APPLICATION NO.	FILING DATE	FIRST NAMED INVENTOR	ATTORNEY DOCKET NO.	CONFIRMATION NO.
10/517,928	12/14/2004	Peter Eichhorst	EICHHORST - 1 PCT	6882
25889	7590	09/25/2007		
WILLIAM COLLARD COLLARD & ROE, P.C. 1077 NORTHERN BOULEVARD ROSLYN, NY 11576			EXAMINER VU, QUYNH-NHU HOANG	
			ART UNIT 3763	PAPER NUMBER
			MAIL DATE 09/25/2007	DELIVERY MODE PAPER

Office Action Summary

DETAILED ACTION

Fig. 1a

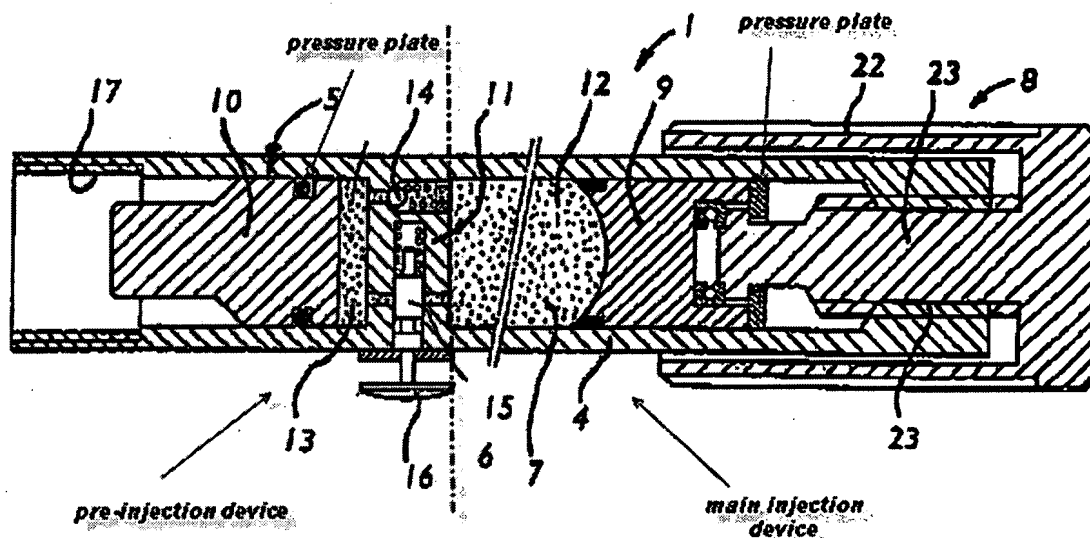
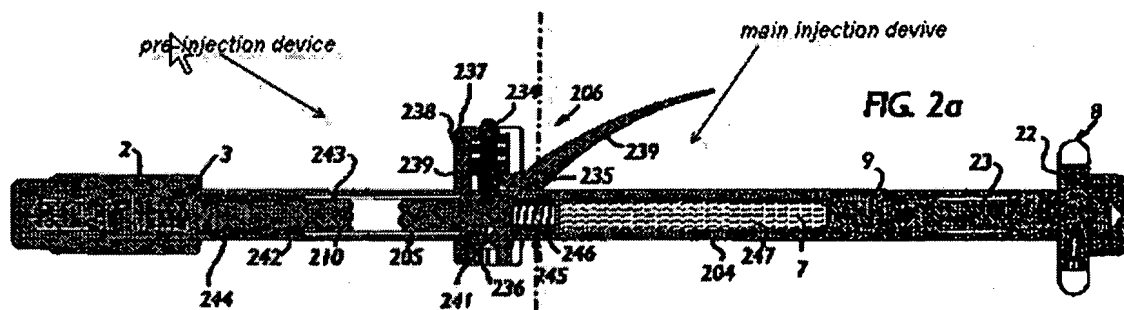
Regarding claim 8, a valve 14 or 15 is disposed within the channel (see Fig. 1a below).

Regarding claims 9-10, a trigger 16 holds a pressure plate biased by a spring (see Fig. 1a below); or a trigger 239 holds a pressure plate 234 biased by a spring 238 (see Fig. 2b below); and a trigger is connected with the chamber 2.

Regarding claim 12, the channel 4 has a connection with the chamber 13, and the valve 14 or 15 is disposed between the connection and the coupling device (Fig. 1a)

Regarding claim 13, the chamber 4 has a piston 9 or 10 that rests against the pressure plate (Fig. 1a).
